SR 141/PEACHTREE ROAD CORRIDOR  
CSMSL-0006-00-(683), Fulton County  
P.I. No. 0006683

Value Engineering Study Report  
Final Design Stage

September 2007

Figure 7. Related studies illustrating the relationship between accident rate and pavement width.

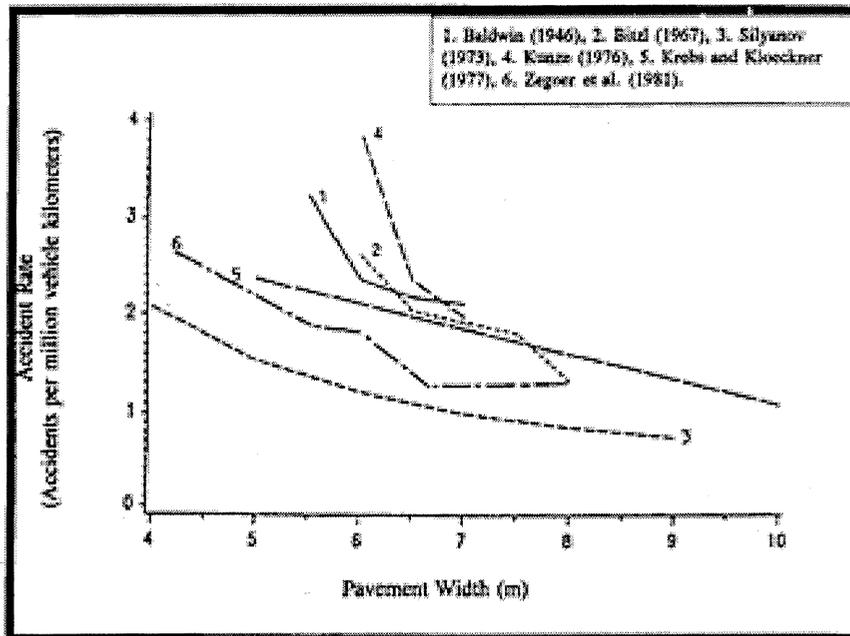
Furthermore, encroachment lag due to the proposed, narrow 10-ft. travel lane and the 11-ft. travel lane will be very severe, especially when personal vehicles are adjacent to buses or large semis. Research studies have generally shown that adequate pavement width is necessary for safe driving operation and thus, by definition, inadequate pavement widths can seriously impair highway safety. Studies from the last 20 years have reported that for every 3.3-ft. increase in pavement width, a decrease in the accident rate of 0.25 per million vehicle miles can be expected. It has been shown that for two-lane rural roadways, lane widening of one foot; e.g., widening a 10-ft. lane to 11-ft., can be expected to reduce accidents such as run-off-the-road, head-on, and opposite- and same-direction sideswipes by 12 percent, and that 4 feet of widening; e.g., from 8-ft. to 12-ft. will result in a 40 percent reduction in these accident types. It has also been reported on before/after comparisons of accident risks, showing that accident ratios decrease with increasing pavement width, as depicted in the figure blow.

As Proposed Typical Section

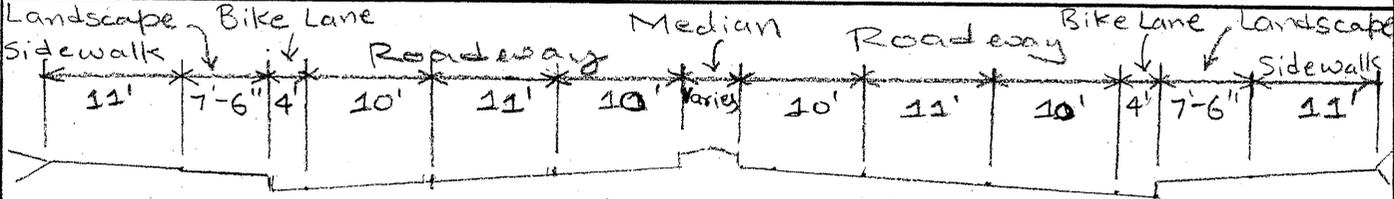
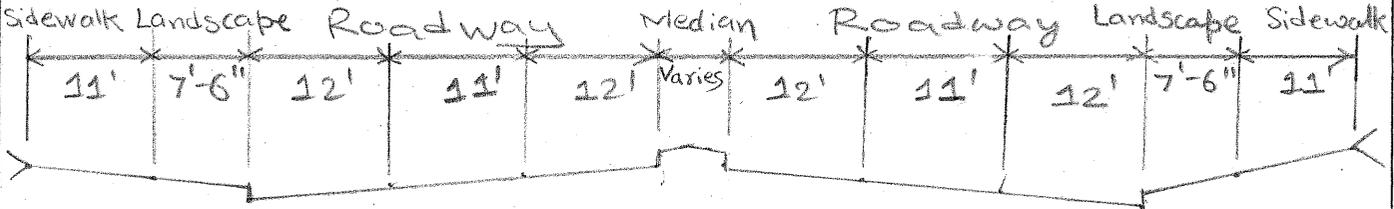
The present design indicates a typical facility section that is composed of an 11-ft. sidewalk, 7.5-ft. landscape zone, 4-ft. bicycle lane, 10-ft. travel lane, 11-ft. travel lane, 10-ft. travel lane, and varying median (normally a 6.5-ft. width), which mirrors itself beyond the median.

Relocate the bicycle lanes to the 11-ft. sidewalks and redistribute the 4-ft. areas to enable the use of 12-ft. travel lanes on the "mainline." The typical section would comprise: an 11-ft. sidewalk, 7.5-ft. landscape zone, 12-ft. travel lane, 11-ft. travel lane, 12-ft. travel lane, and varying median (normally a 6.5-ft. width), which mirrors itself beyond the median.

Alternative Typical Section

As Proposed Typical Section

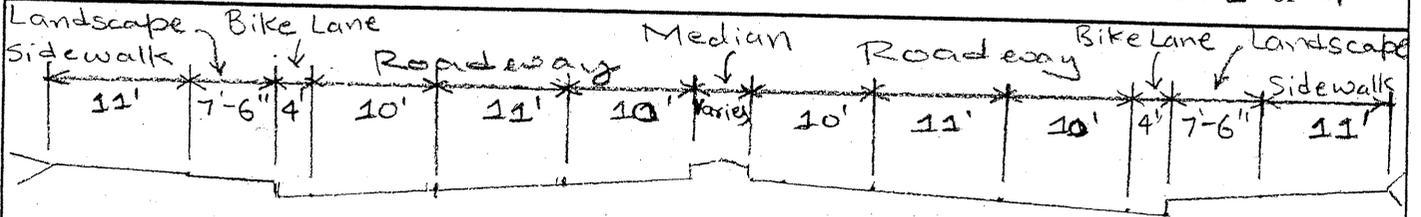
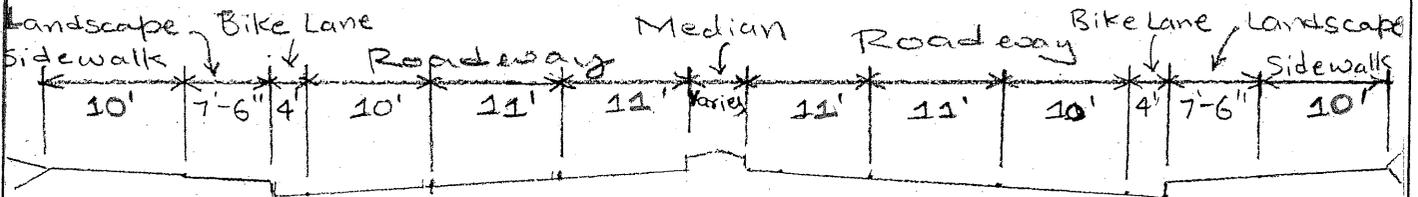
See discussion of related lane widening in Alt. No. 1.

Alternative Typical Section

*As Proposed*  
**B MEDIAN-SECTION 'B'**  
 29-15 SCALE: 1" = 1'-0"  
 FILE NO. 29-15-10-10

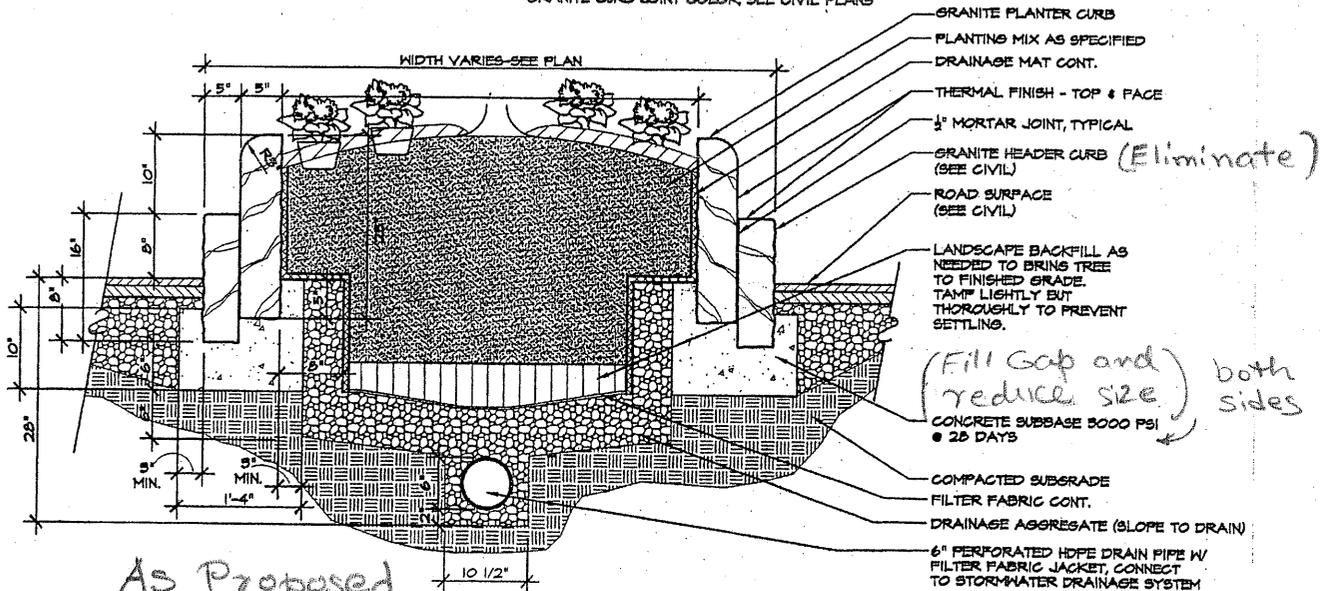
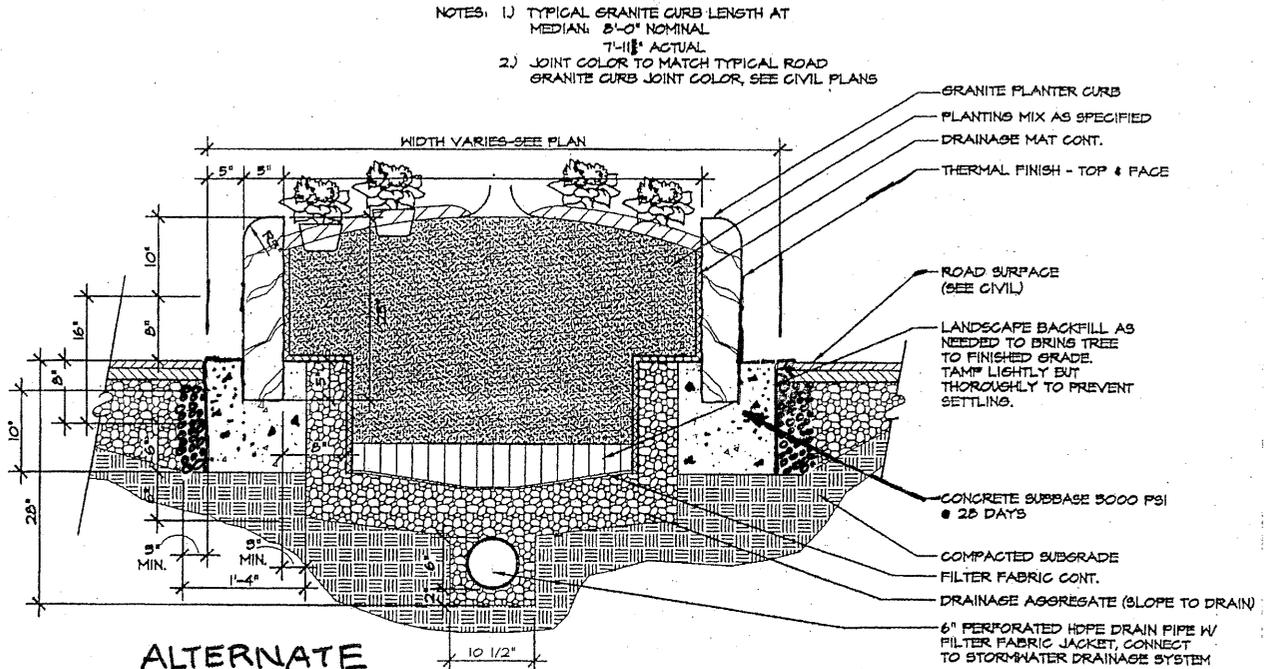
NOTES: 1) TYPICAL GRANITE CURB LENGTH AT  
 MEDIAN: 8'-0" NOMINAL  
 7'-11" ACTUAL  
 2) JOINT COLOR TO MATCH TYPICAL ROAD  
 GRANITE CURB JOINT COLOR, SEE CIVIL PLANS

**H** PLANTER-SECTION 'B'  
 29-13 SCALE: 3/4" = 1'-0"  
 FILE NAME: 0006-PLANTER-SECTION B

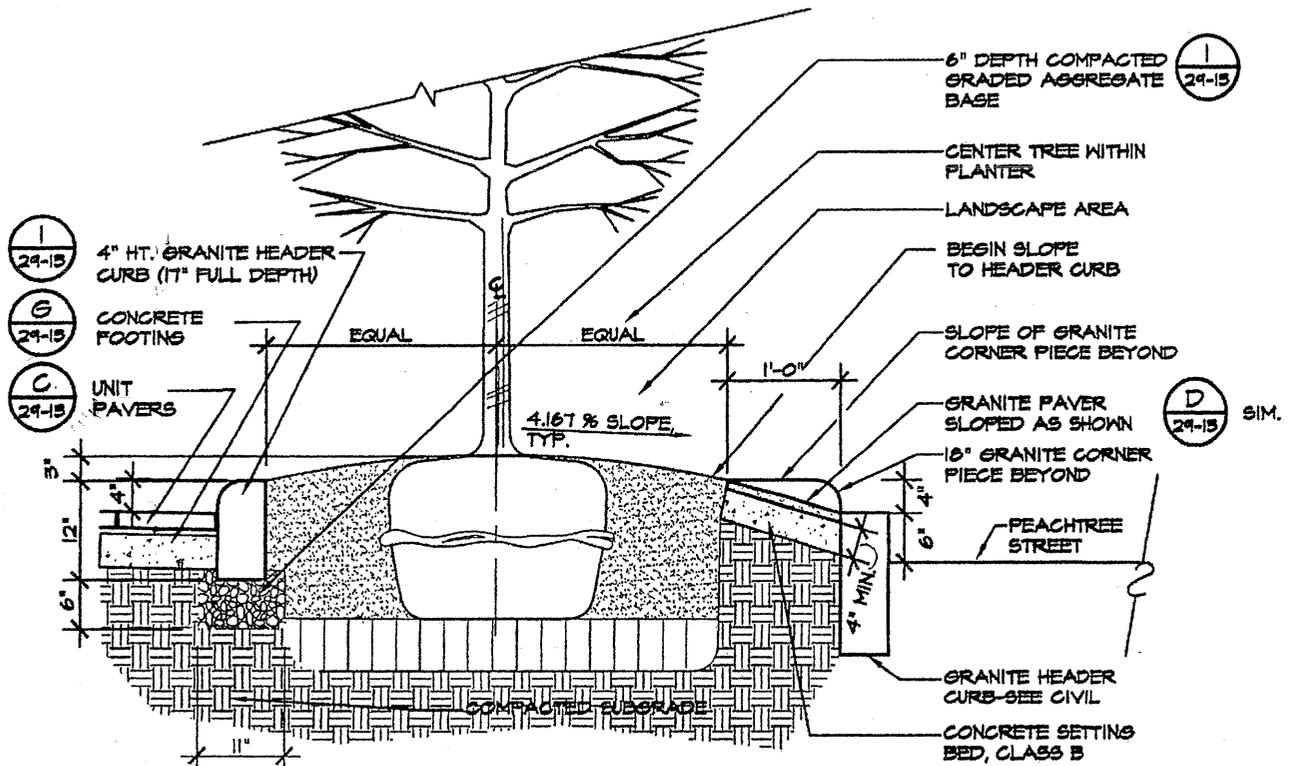
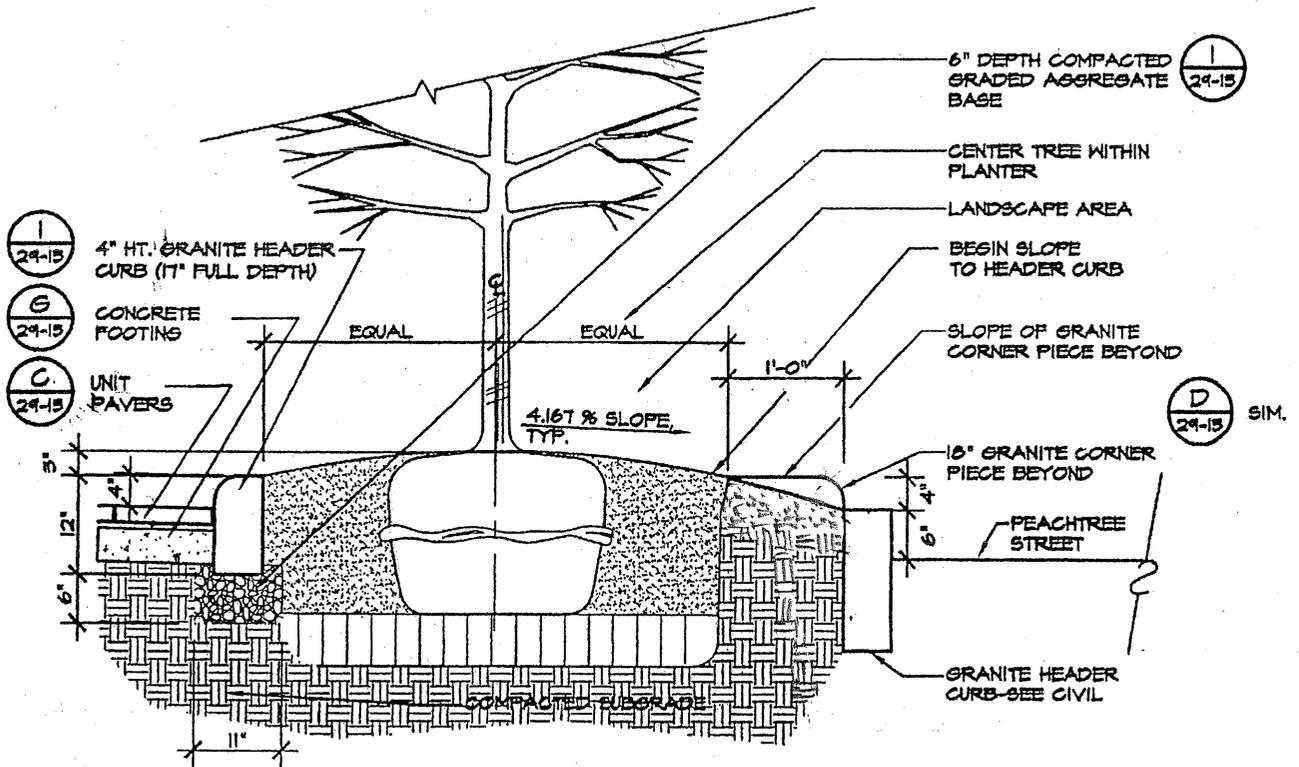
The 1-ft. x 1-ft. sloped granite pavers appear to improve the overall aesthetic quality of the corridor. A visit to the site to observe the Phase I work that employs this detail indicated a lack of quality in the placement and alignment of these granite pavers, leading to an “unkempt” appearance. This alternative allows for a softer edge that is in-keeping with a landscaping strip precluding such an appearance.

**B** MEDIAN-SECTION 'B'  
 29-15 SCALE: 1" = 1'-0"  
 FILE NAME: MEDIAN.B

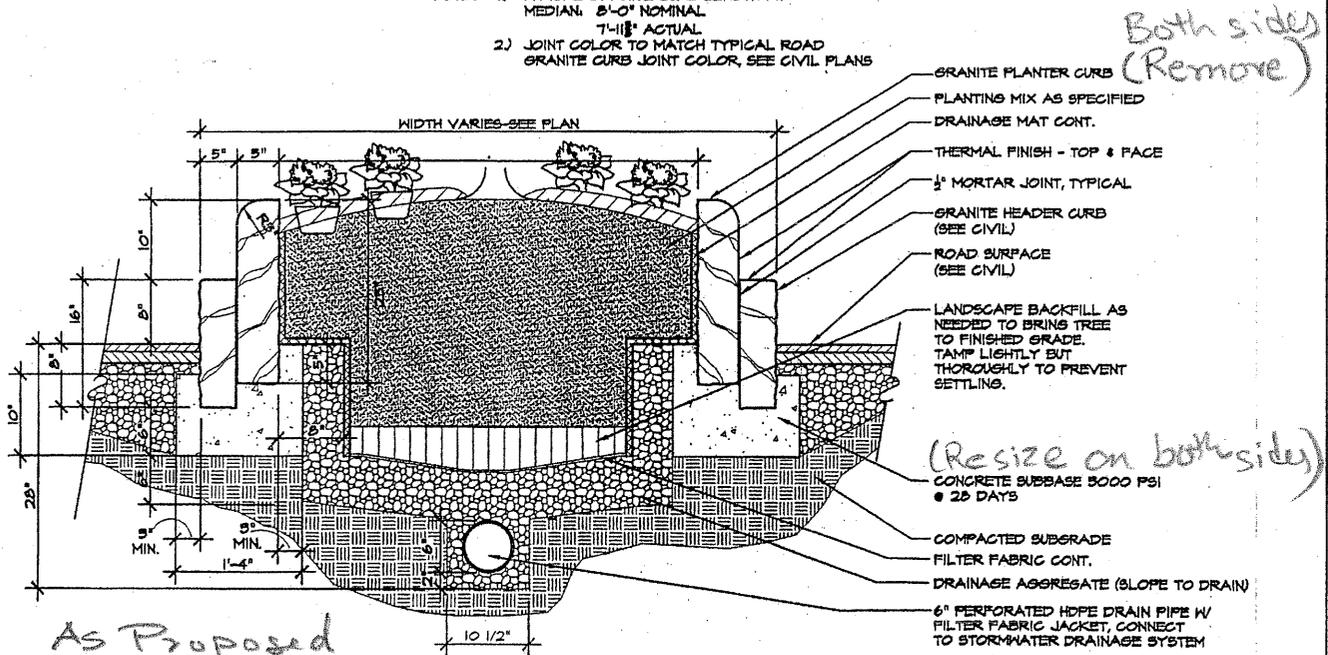
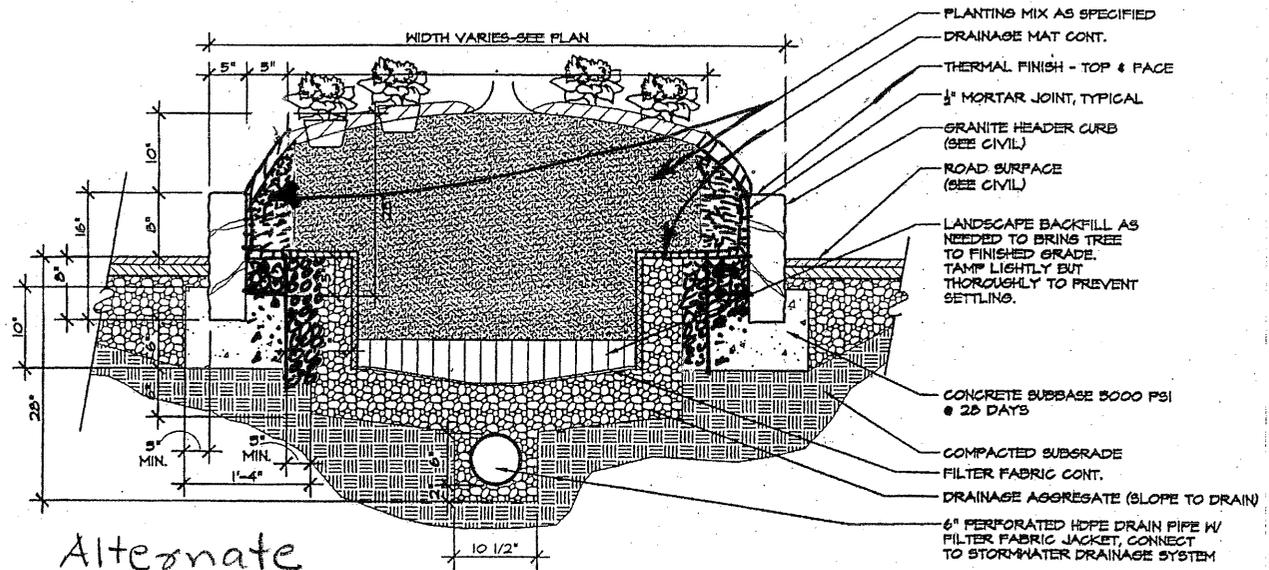
Having two granite curbs side-by-side throughout the project appears to be unnecessary with little or no benefit to the project other than aesthetics. By eliminating the larger of the two curbs, 10 in. of additional median is gained, allowing more room to supplement the current landscaping plan.

**D** STONE PAVEMENT AND TYPICAL CONTROL JOINT SECTION - PEDESTRIAN  
 24-15 SCALE: 1/2" = 1'-0"

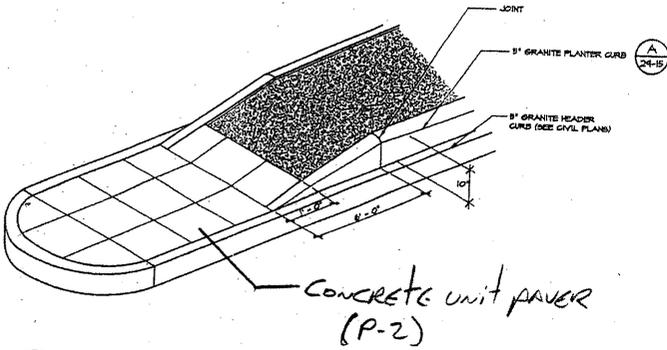
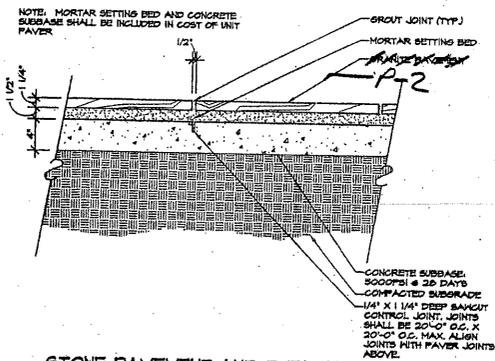
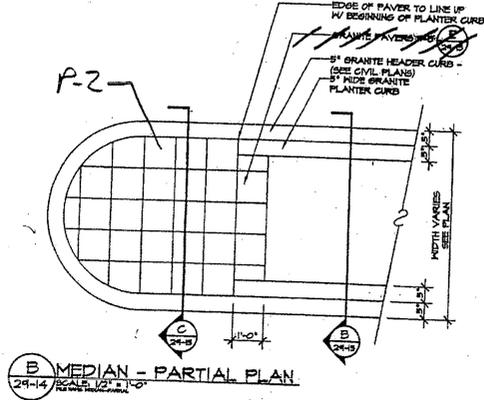
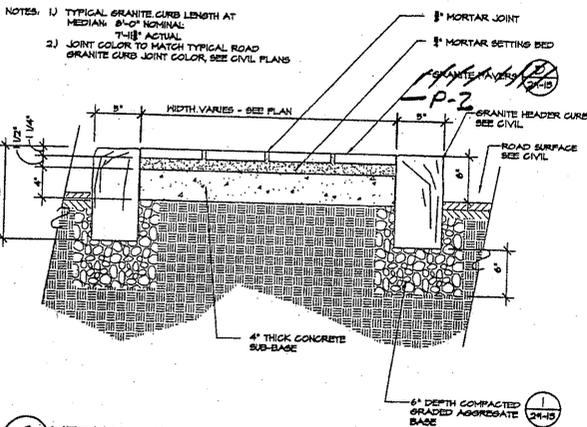
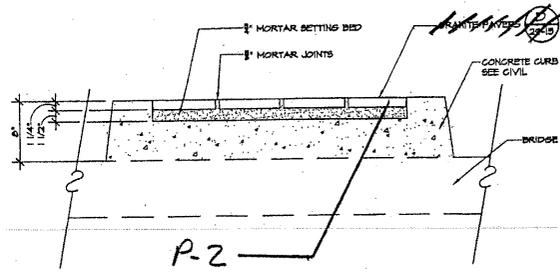
Concrete pavers can be installed the same time the sidewalk is constructed. Larger quantity of concrete pavers will further reduce its unit price due to an economy of scale. The same function is achieved with concrete at a reduced cost.

\* Typical: Replace granite pavers with concrete unit pavers

**B** MEDIAN-SECTION 'B'  
 29-15 SCALE: 1" = 1'-0"  
 FILE NO. 29-15-000-00

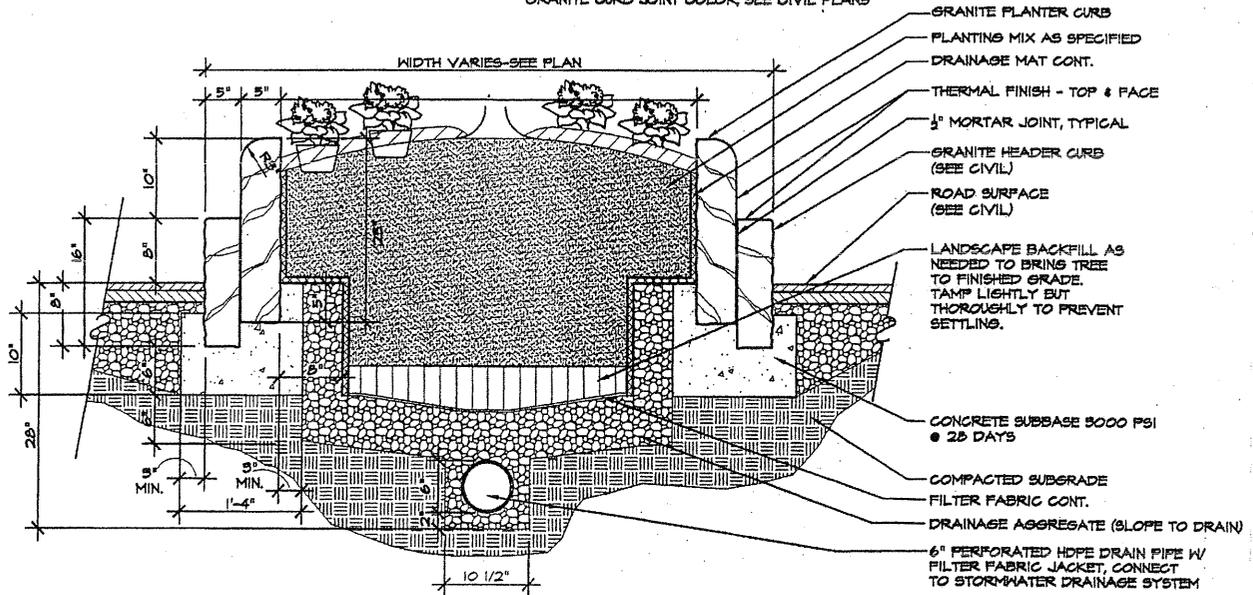
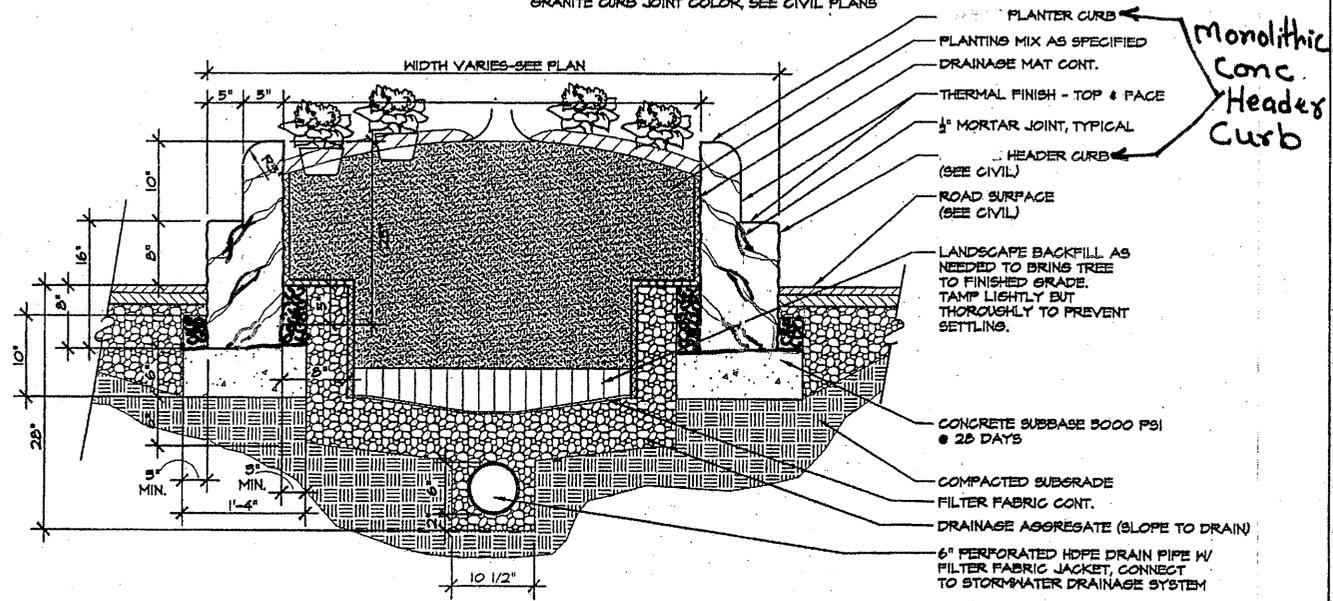
NOTES: 1) TYPICAL GRANITE CURB LENGTH AT  
 MEDIAN: 5'-0" NOMINAL  
 7'-11 1/2" ACTUAL  
 2) JOINT COLOR TO MATCH TYPICAL ROAD  
 GRANITE CURB JOINT COLOR, SEE CIVIL PLANS
